Product/Process Change Notification / PCN

Affected Product Prosilica GT3300C, Prosilica GX3300C

PCN Title Discontinuation of Prosilica GT/GX3300C cameras with KAI-08050 color sensor

PCN No. PCRREVB-350 **PCN Issue date** 2015-Dec-10

Figure 8. Quantum Efficiency: Color Bayer with Microlens and AR Glass Configuration. KAI–08051 compared to KAI–08050.

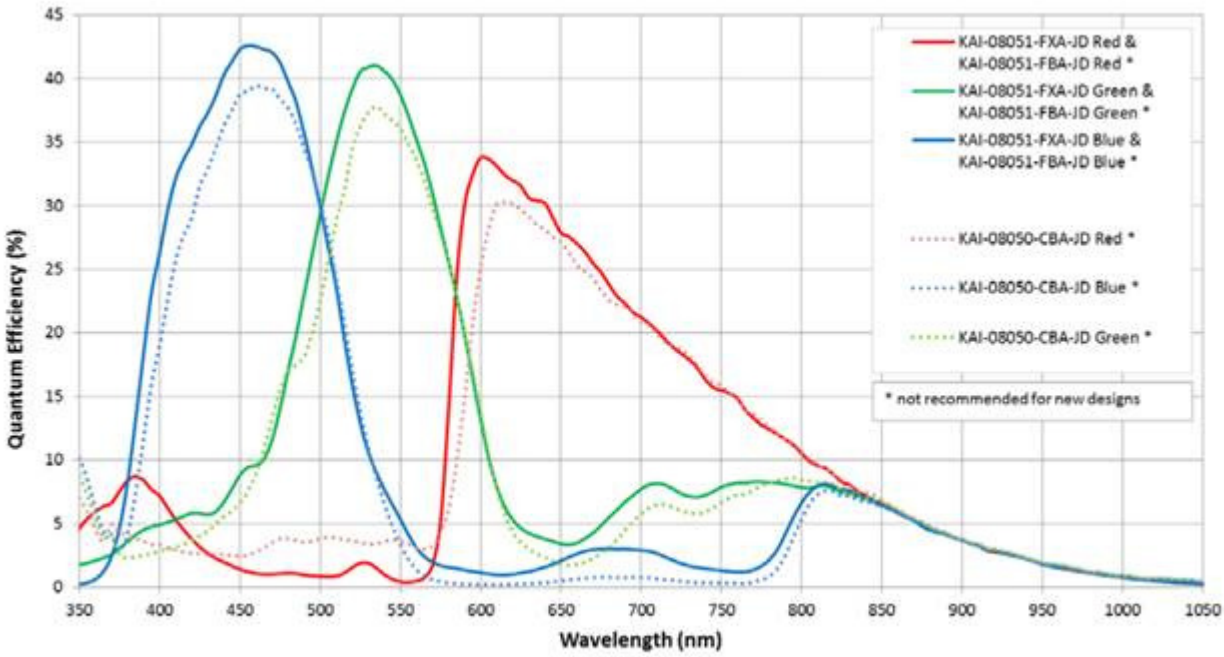
In addition, OnSemi has changed the materials used in their Color Filter Array for color KAI-08051 sensors. As shown in Figure 8 (Provided by OnSemi), and validated through final image comparison, the change in color balance is undetectable between KAI-08050 and KAI-08051. Please refer to the “FXA” variants when comparing the sheet.
